**7TH AVE TOWNHOMES  
BUILDING A**

<b>ISSUE</b>	<b>DATE</b>
BLDG PERMIT APPLICATION	03/06/2025
PERMIT COMMENTS	04/29/2025

**City of Puyallup**  
Development & Permitting Services  
**ISSUED PERMIT**

**City of Puyallup Building REVIEWED FOR COMPLIANCE**

MAIN LEVEL HVAC PLAN SCALE: 1/4" = 1'-0"

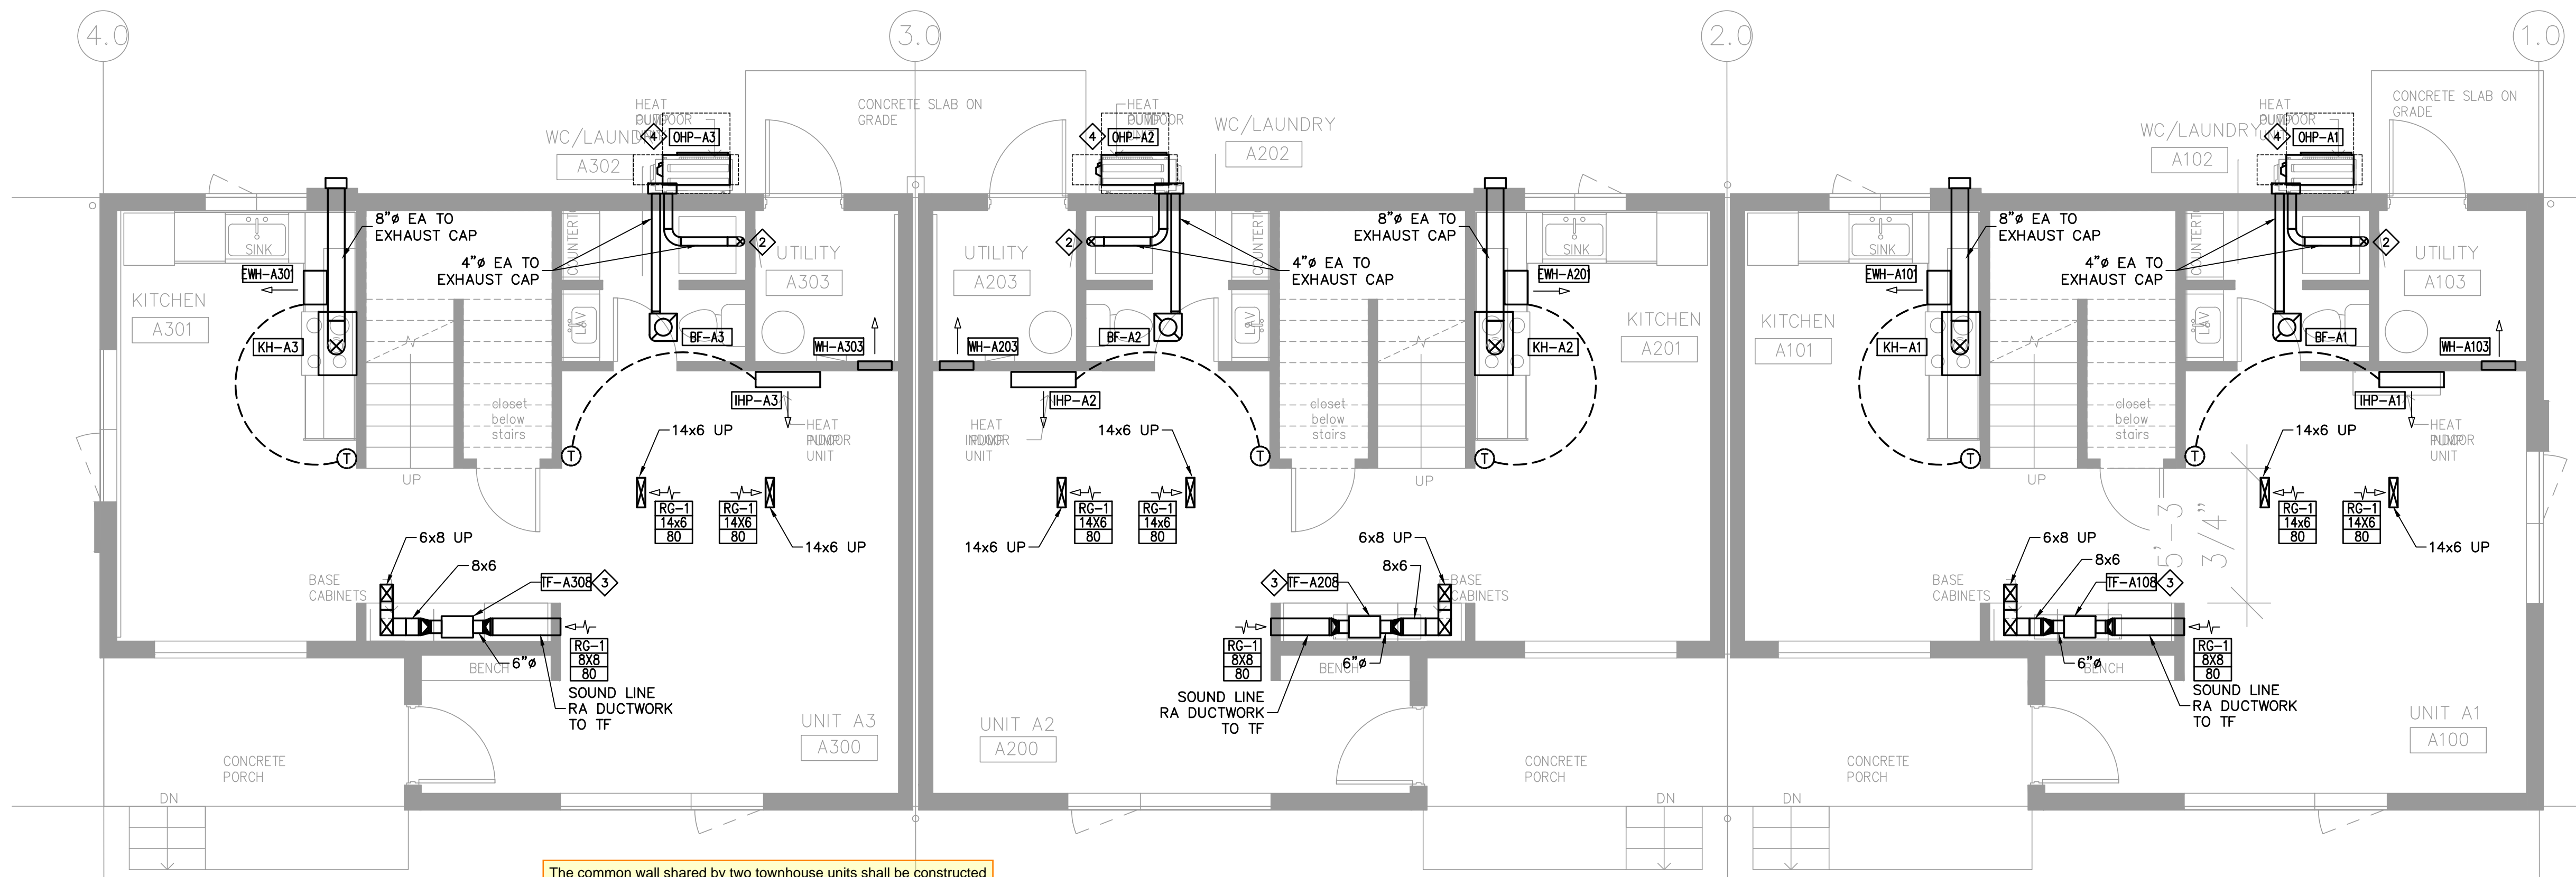
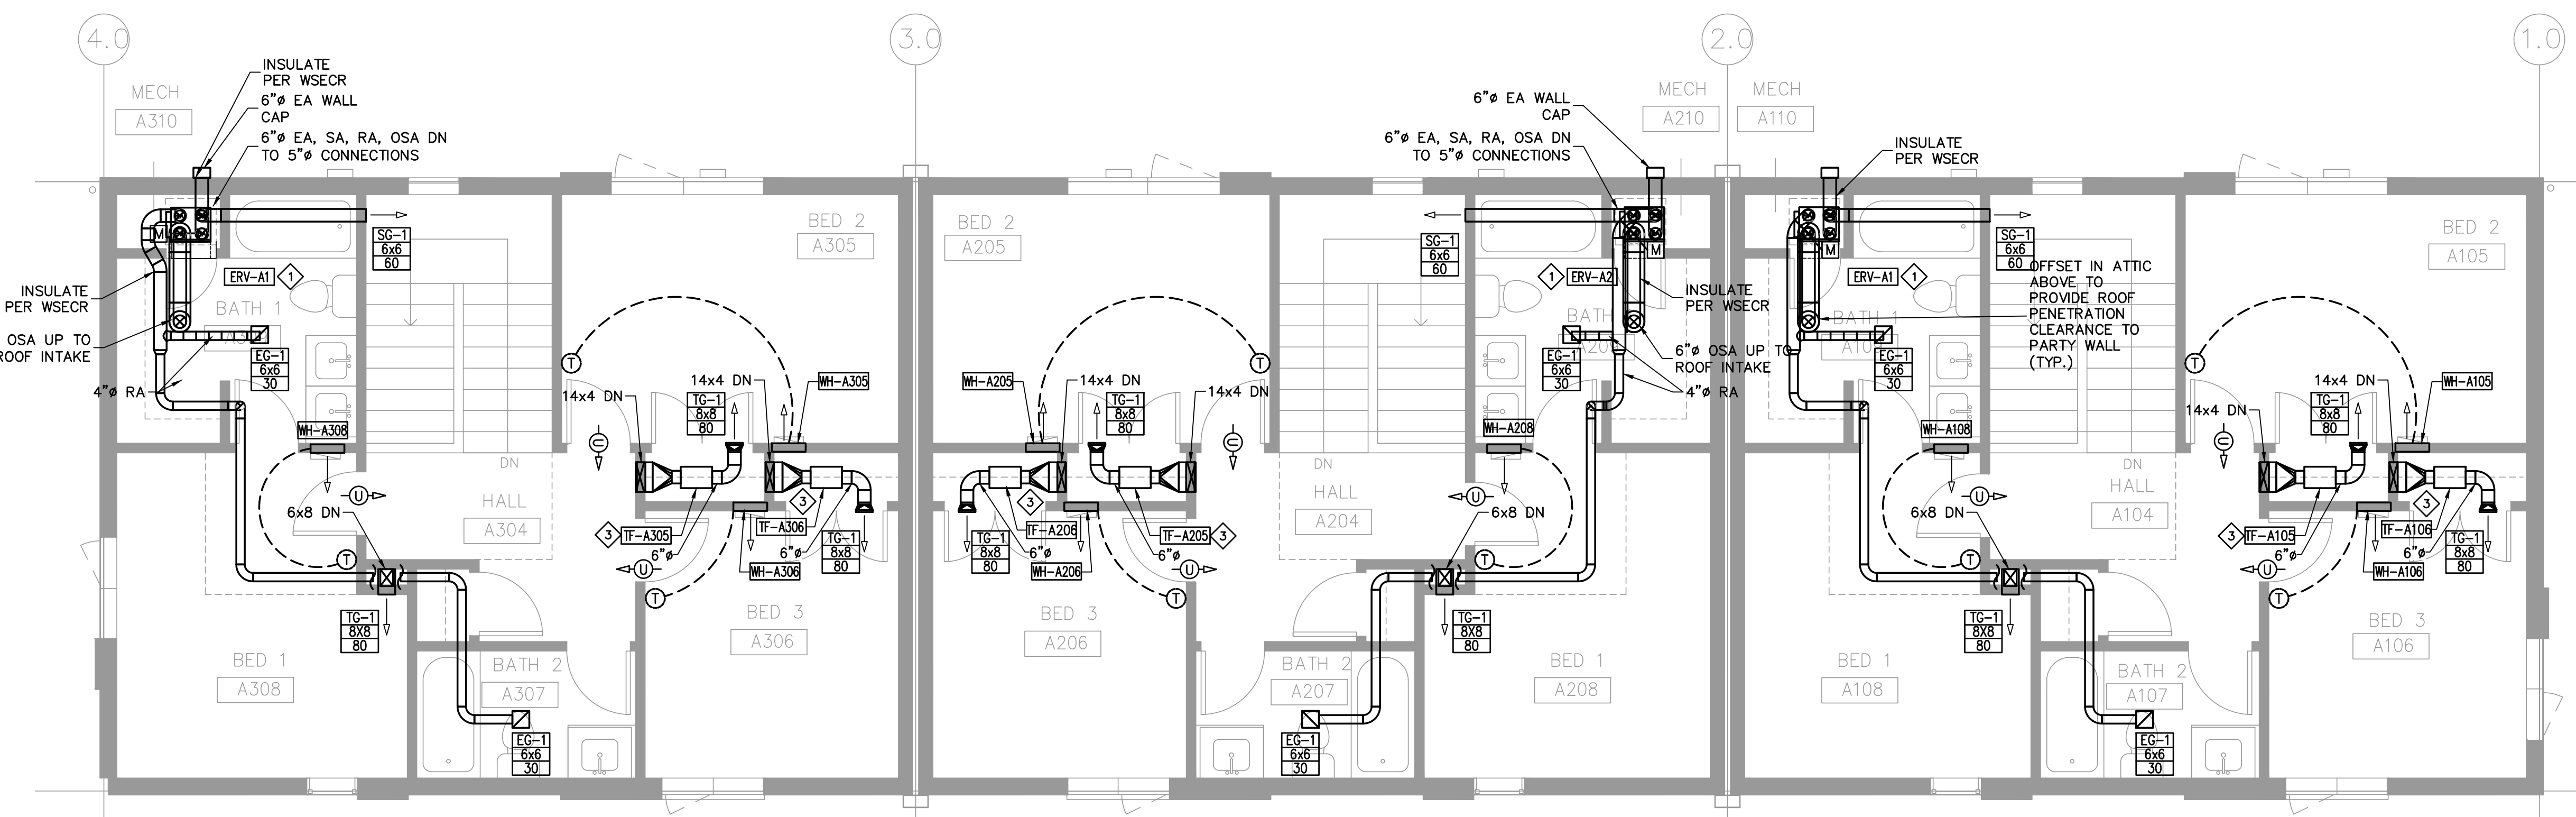
The common wall shared by two townhouse units shall be constructed without plumbing or mechanical equipment, ducts or vents, other than water-filled fire sprinkler piping in the cavity of the common wall, per section R302.2.2 of the 2021 Washington State Residential Code.

The common wall shared by two townhouse units shall be constructed without plumbing or mechanical equipment, ducts or vents, other than water-filled fire sprinkler piping in the cavity of the common wall, per section R302.2.2 of the 2021 Washington State Residential Code.
